**Federal Aviation
Administration**

FAA Initiative to Address Noise Concerns of Santa Cruz/Santa Clara/San Mateo/San Francisco Counties

UPDATE ON PHASE TWO

November 2017

Figure A1: Comparison of Golden Gate arrivals (May 2014) and BDEGA arrivals (May 2016)

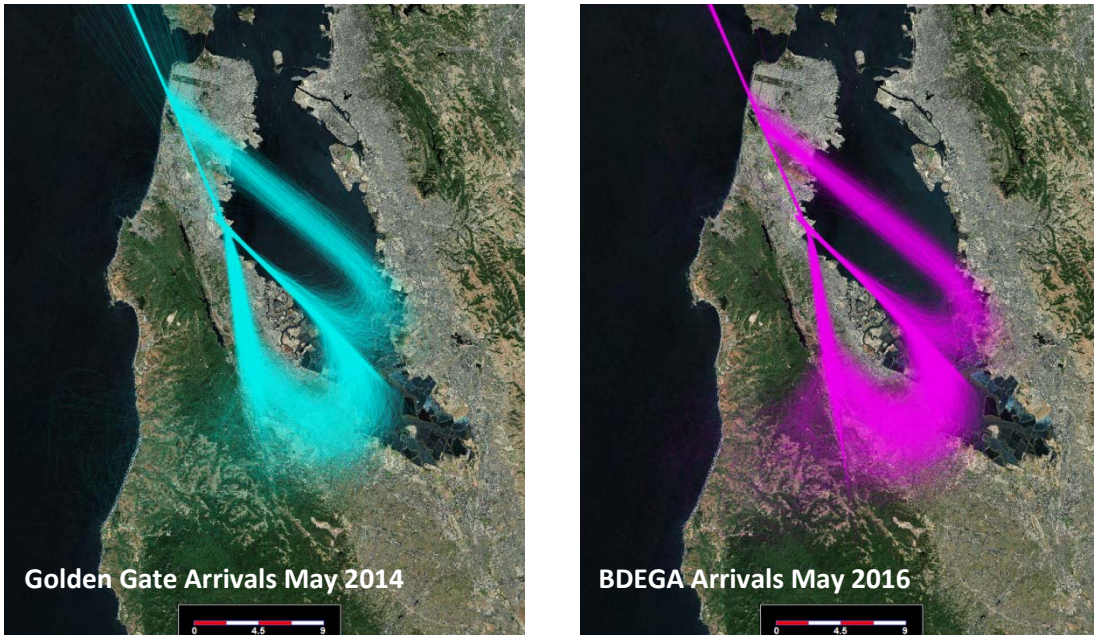
2.4 The FAA provide data on Golden Gate/BDEGA lateral track locations pre-NextGen and post-NextGen and if new procedures can use headings, not tracks, in procedure design.

The FAA reviewed the identified arrivals: the Golden Gate and BDEGA arrivals. The Golden Gate arrival states, “...via SFO R-303 to SFO VOR/DME. Expect RADAR vectors to final approach course.” Aircraft that flew this arrival navigated to the SFO VOR/DME via the SFO 303° radial, which is a conventional, or non-precision, method of navigation. Upon reaching the SFO VOR/DME, aircraft on the Golden Gate arrival were typically instructed to fly a 140° heading. Note, the Golden Gate arrival does not stipulate a 140° heading.

Therefore, aircraft that historically flew the Golden Gate arrival and that currently fly the BDEGA arrival essentially perform the same maneuver after crossing SFO/DME / BRIXX. Figure A1 (above), a review of one month of Golden Gate arrival aircraft (Teal) and one month of BDEGA arrival aircraft (Pink), supports this conclusion.

Figure A2: SEPDY Reporting Point relative to SSTIK waypoint.

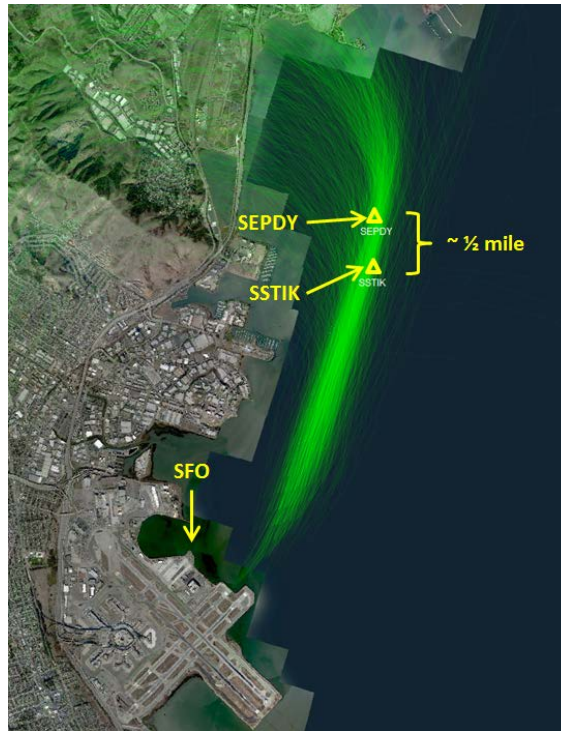
2.37 SSTIK: Avoid non-safety vectoring prior to SEPDY waypoint.

SEPDY is a reporting point from the conventional PORTE and OFFSHORE departure procedures. The SSTIK RNAV departure, which serves as PORTE and OFFSHORE's replacement for nearly all southbound aircraft, does not include the SEPDY reporting point. While not a part of the SSTIK departure procedure, the point in space that is SEPDY already sees the majority of SSTIK departures passing through it, as illustrated above in Figure A2.

Figure A3: BDEGA / DYAMD / Bay Area Airspace

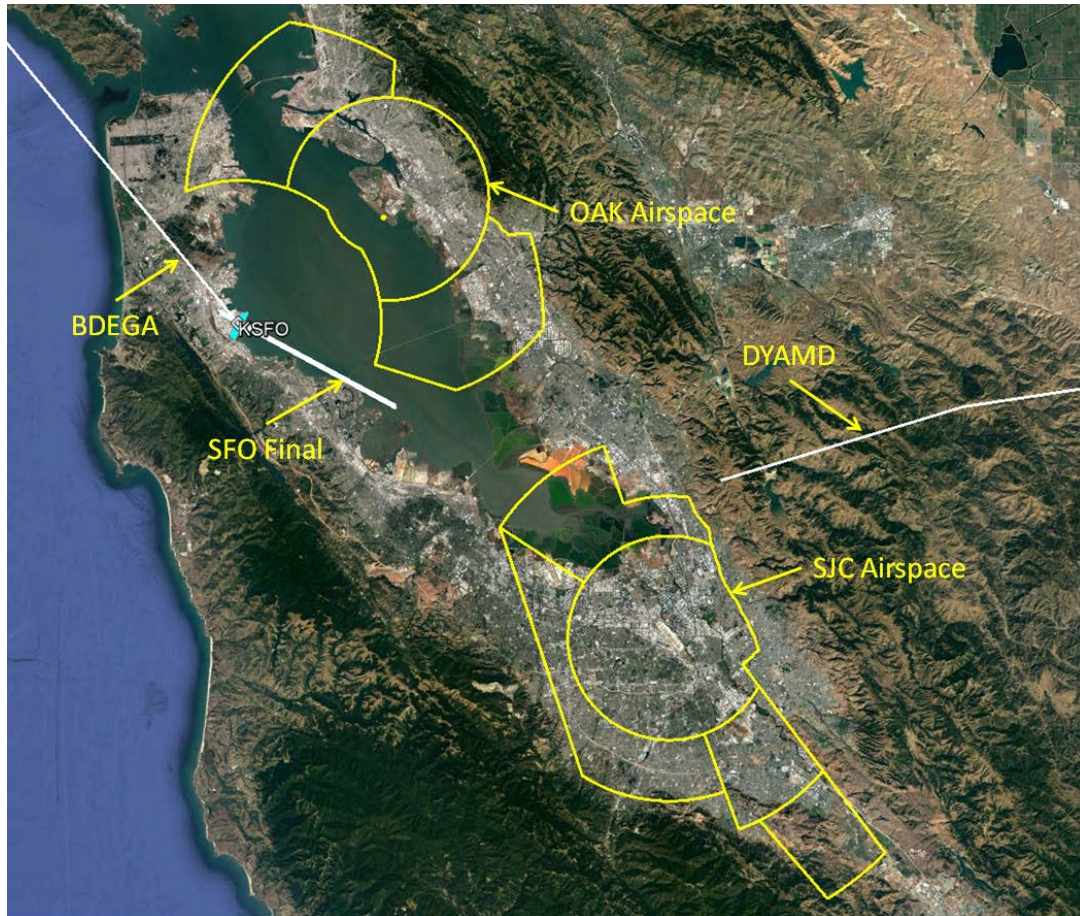
3.12 Research reasons for the continued increased use of the BDEGA west leg from May 2010 – present.

SFO operations have increased 4% from 2014 to 2016, with an 18% and 4% increase in the BDEGA and DYAMD arrivals, respectively. It is important to understand that this increase in volume and the times of day that they fly is a result of Air Carrier scheduling. The FAA’s role is to safely manage these aircraft from the time they push back from their departure airport jet way to the time that they reach their arrival airport jet way.

As noted in Figure A3 and in previous meetings with the Select Committee and SFO Roundtable, the ability to route a BDEGA arrival to the East downwind is dependent on the density of aircraft on the DYAMD arrival and the volume of traffic landing at OAK. Straight-in aircraft, as aircraft on the DYAMD arrival are to SFO, largely have priority over aircraft on the downwind. The reason for this is DYAMD aircraft are constrained by surrounding airspace to the North and South (OAK and SJC, respectively), and vectoring aircraft on the straight-in affects every trailing aircraft in the line – increasing the controller’s workload significantly. The same is true, to a smaller degree, of aircraft on the East downwind. This leg also has the constraint of OAK airspace to the North and the SFO Final to the south, leaving very little room to maneuver aircraft for a sequence. Because of these two limiting factors, aircraft on the BDEGA can only be routed

Figure D1: Intercept FAC below the glideslope

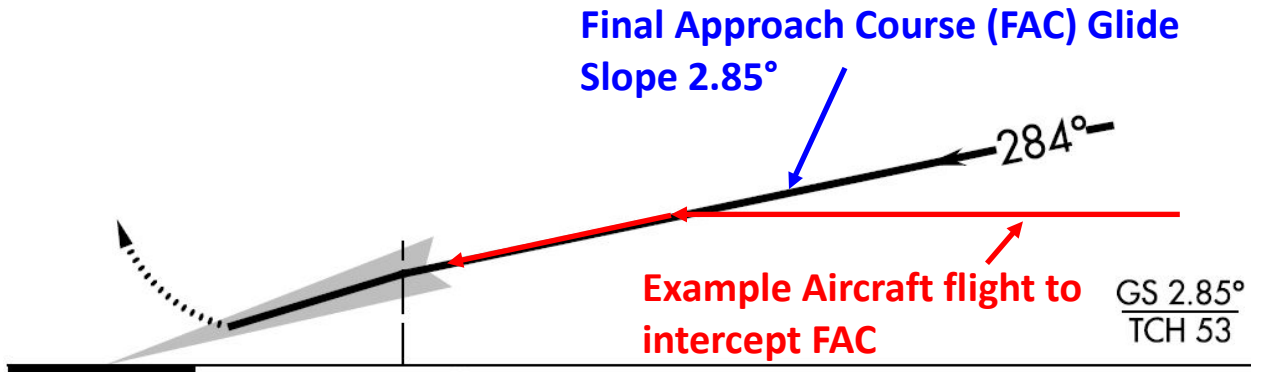
1.21 All air traffic in the vicinity of the MENLO waypoint (including vectored traffic from other procedures) be kept at altitudes of 5,000 feet or higher, even if not crossing directly over the MENLO waypoint.

The average altitude of vectored traffic in the vicinity of MENLO waypoint is approximately 4,600 feet MSL. Aircraft that fly in the vicinity of MENLO with the intention of landing on Runways 28L or 28R at SFO are subject to the same descent requirements of those that cross MENLO on an arrival. Those requirements are detailed in the FAA's NorCal Phase One Report, 1.a.i. and Appendix D. For safety considerations, and to fly a stabilized approach, aircraft must be descended in order to intercept (join) the Final Approach Course (FAC) at or below the glideslope (See Figure D1).

Figure D5: Graphical Depiction of Routes

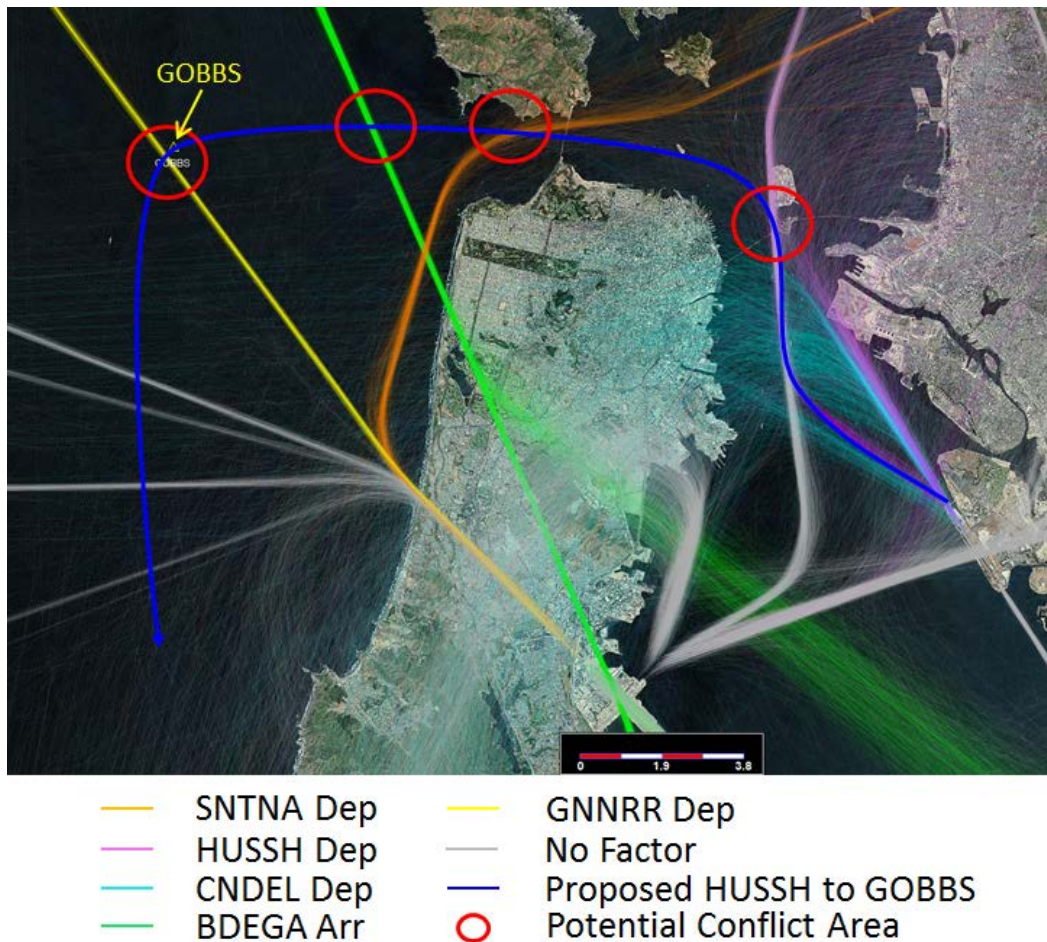
2.31 Determine if a revised southbound transition (with additional waypoints) for the CNDEL procedure could “contain” the flight paths further west (GOBBS and south) to allow expanded clear space for possible modification of the SSTIK departure.

In the above image (Figure D5), the teal tracks represent current CNDEL departures, while the pink tracks represent current HUSSH departures. The blue line approximates the FAA’s understanding of the Roundtable’s recommendation – that the CNDEL departures (teal), a day and nighttime departure procedure, be routed on a track approximating the blue line to GOBBS, then South. CNDEL, as it is published today, is designed to be laterally separated from SSTIK
